## ADDENDUM #01

ACES at CHASE

STATE PROJECT NO. 244-0044 MAG

6. **ALL Bidders** should review and incorporate the **attached Bulletin #1 dated December 16, 2025** prepared by **S/P+A** and their consultants. This Addendum includes:

E210-1

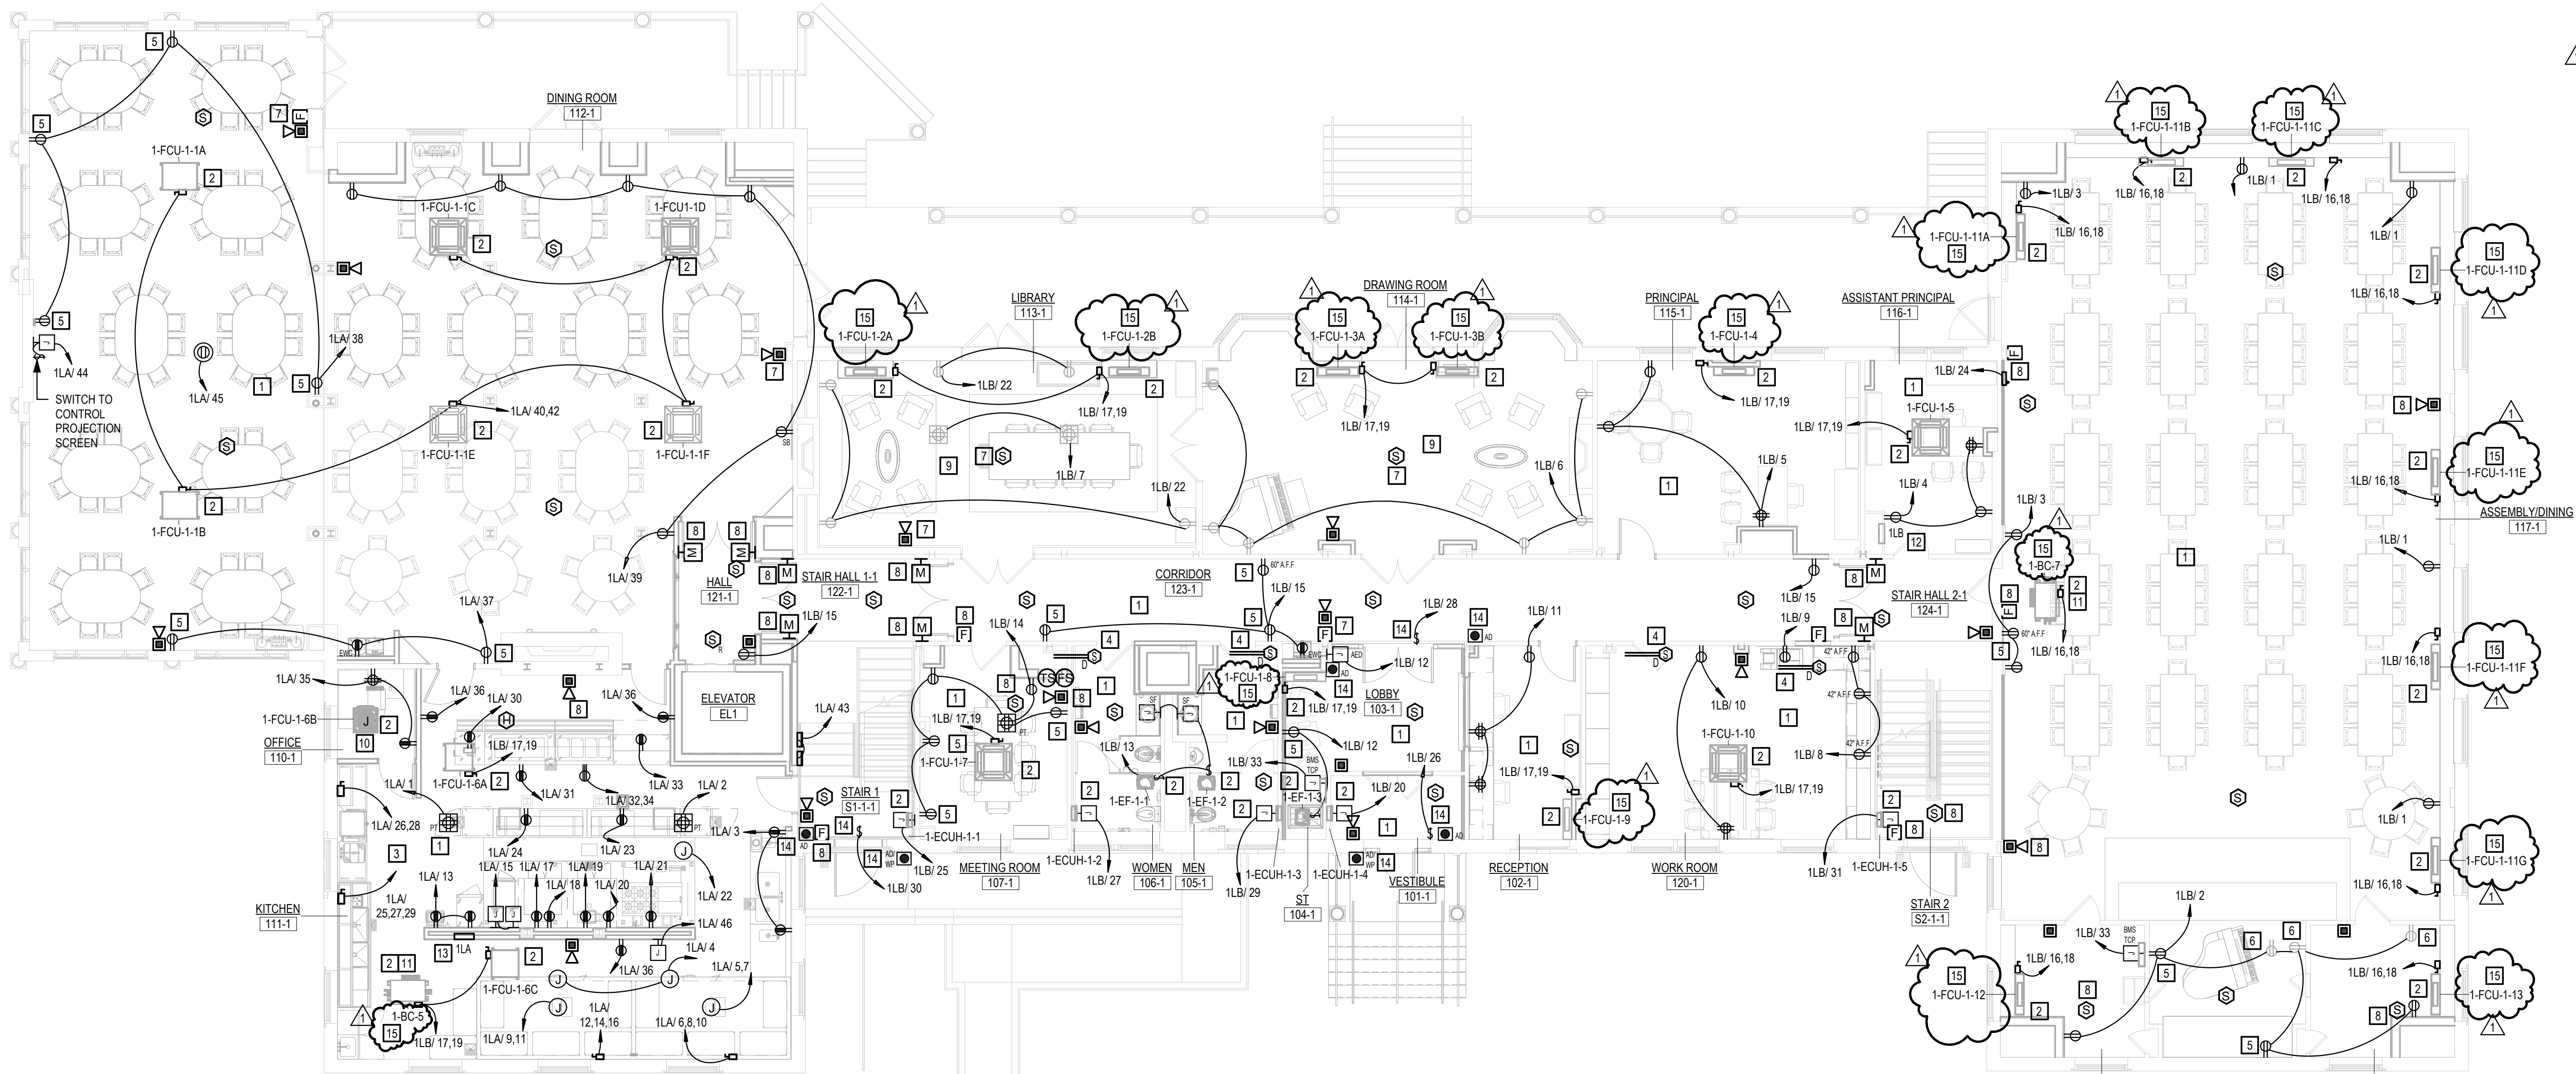
- E200-1 BUILDING 1 – BASEMENT LEVEL POWER PLAN *(Per Internal Review)*
    - E210-1 BUILDING 1 – MAIN LEVEL POWER PLAN *(Per Internal Review)*
    - E220-1 BUILDING 1 – SECOND LEVEL POWER PLAN *(Per Internal Review)*
